General Information

Radiator Rebuilding

**Western Star
 Service Bulletin**

Fig. 1, Bolted Copper-Brass Downflow Radiator Assembly

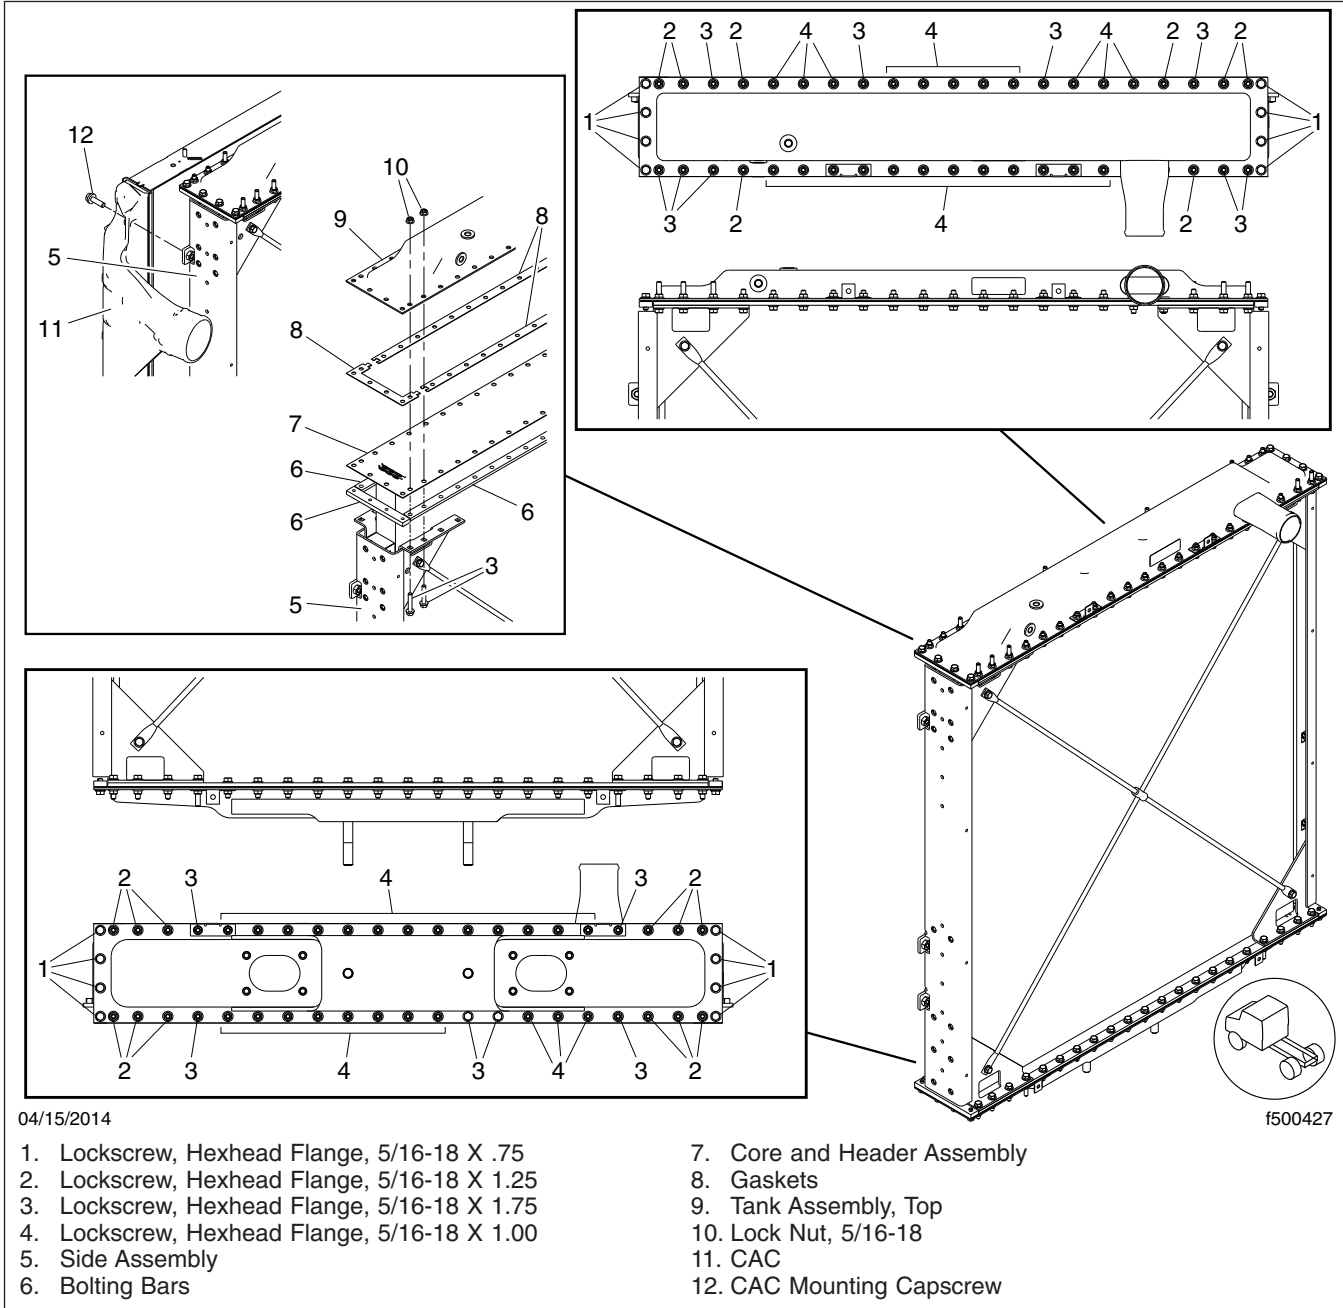
Modine Manufacturing has changed their procedure for replacing the tank gaskets on copper/brass bolted downflow radiators. See "Radiator Rebuilding" below for the current approved procedure. Replacing the tank(s) is no longer required. Adding silicone sealer to the gasket ends is no longer an acceptable practice.

Subject 20.02, 130 of the *Western Star Workshop Manual* is revised to reflect these changes.

1. Remove the radiator from the vehicle. For instructions, refer to [Subject 20.02, 100](#) of the *Western Star Workshop Manual*.
2. Remove the CAC.
3. Remove and discard the tank bolts, nuts, gaskets, and bolting bars. Do not reuse these items.
4. Clean the gasket sealing surfaces.
5. Position the gasket segments.

6. Position the tank, new bolting bars, and new hardware as shown in [Fig. 1](#).

8. Install the CAC. See [Fig. 1](#) for installation detail. Tighten the mounting nuts 26 lbf-ft (35 N·m).
9. Install the radiator. For instructions, refer to [Subject 20.02, 100](#) of the *Western Star Workshop Manual*.
